**RESOLUTION HOLDING HEARING ON REQUEST FROM RIVER POINT WEST, LLC TO AMEND PUD CONCEPTUAL PLAN FOR PROPERTY LOCATED AT 205 SOUTHWEST 11<sup>TH</sup> STREET**

(ZON2019-00206)

Communication from the City Plan and Zoning Commission advising that at their November 7, 2019 meeting, the following action was taken regarding a request from River Point West, LLC (owner) represented by George Sherman (officer) for review and approval of the 5<sup>th</sup> Amendment to the Gray's Landing Office Park I PUD Conceptual Plan on property located at 205 Southwest 11<sup>th</sup> Street to reconfigure the location of a 3-story office building with 68,000 square feet of office and 4,500 square feet of restaurant space along with associated surface parking. The currently approved building would have indoor parking. Additional property in the PUD is owned by Sherman Grays Landing Hotel Development, LLC.

FOURTH AMENDMENT RIVER POINT WEST (ZON2105.00073)  
 A PLANNED UNIT DEVELOPMENT  
 IN THE CITY OF DES MOINES, COUNTY OF POLK, STATE OF IOWA  
 SHEET 2 OF 4

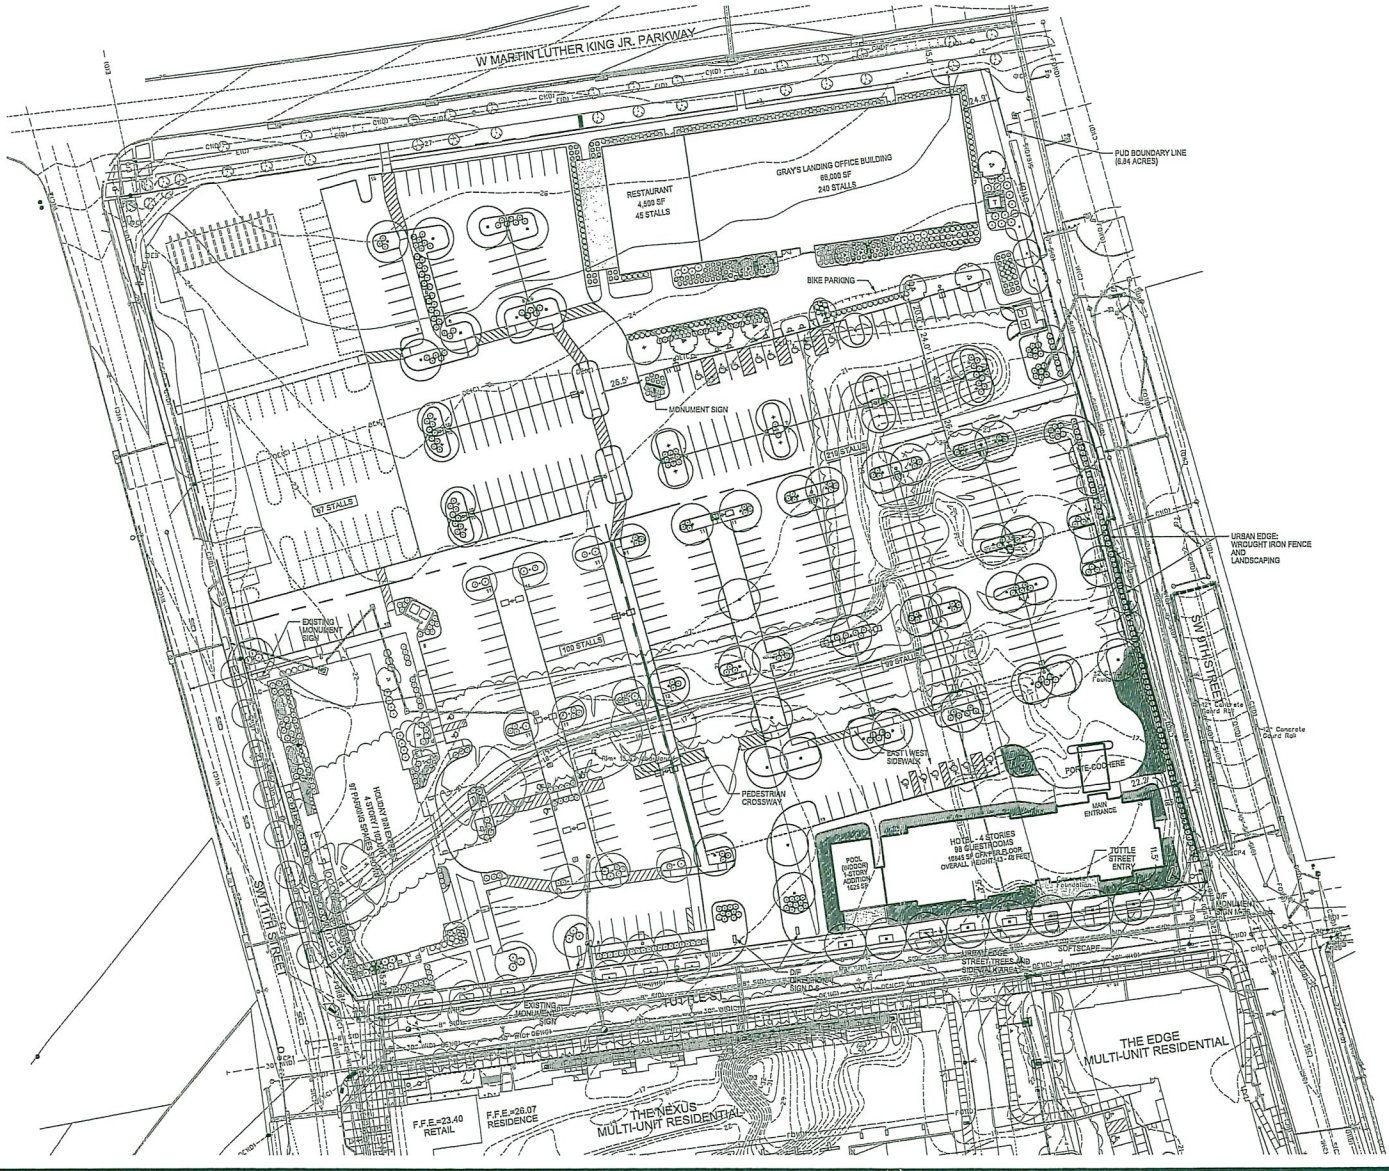
5. **Landscaping:** The proposed PUD Conceptual Plan states that the site will be landscaped in accordance to the Landscape Standards as applicable to the “C-3” District. It also states that an urban edge consisting of a decorative fence and additional landscaping including trees and shrubs shall be provided in all locations where off-street parking is within 50 feet of a property line and not separated from the right-of-way by a building. The proposed PUD Conceptual Plan demonstrates a mix of overstory trees, ornamental trees, shrubs, and landscaping beds within the parking lot areas but does show plantings along either West Martin Luther King, Jr. Parkway or along Southwest 11<sup>th</sup> Street. Staff recommends that the PUD Conceptual Plan be revised to demonstrate landscaping material along both West Martin Luther King, Jr. Parkway and Southwest 11<sup>th</sup> Street frontages.

9. Sheet 2 shall be revised to demonstrate landscaping material along both West Martin Luther King, Jr. Parkway and Southwest 11<sup>th</sup> Street frontages
